CHANGE ORDER #3 – SUMMARY BULLITT CENTRAL TRACK ELEVATIONS

BULLITT COUNTY PUBLIC SCHOOLS BOARD OF EDUCATION – APRIL 24, 2023

CHANGE ORDER #2 – PRELIMINARY SUMMARY NORTH BULLITT TRACK ELEVATIONS

CHANGE ORDERS HIGH SCHOOL FOOTBALL STADIUM – CONSTRUCTION UPDATE

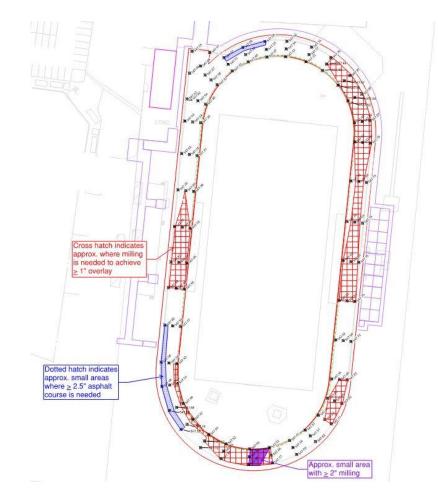
SKA and TKG have reviewed the existing elevations at North Bullitt with Calhoun to come to a recommendation to the District to address the unevenness of the existing NBHS Track relative to new work. Based on this review we are recommending the Construction Team fully removes the existing asphalt down to existing soil and return with the full track depth in lieu of selective milling. The end result of this will be a flat track that matches sport regulations and is consistent across the entire surface.

Ahead of this recommendation – the Design Team went through the exercise of identifying the areas of selective milling and replacement of portions of the track to mitigate the elevation changes in an attempt to return to the original design intent of reusing the track that was installed 7-years ago. Through that exercise though, Calhoun's team would still have needed to do additional Work to correct the uneven elevations. The cost of this was estimated to be \$7,282.60. Even though this was a lessor price, we felt that this process had the potential of delaying the Contractor's schedule and would not yield the best end-result for NBHS and the District. You can see the process of this exercise through the provided graphic that shows the areas of milling and add – as indicated in the attached plan, the track has a lot of uneven areas due to existing elevations.

Cost to provide an entire new track section in lieu of selective milling is estimated to be \$16,387.25. This change also allows for greater control over the project schedule by the Contractor.
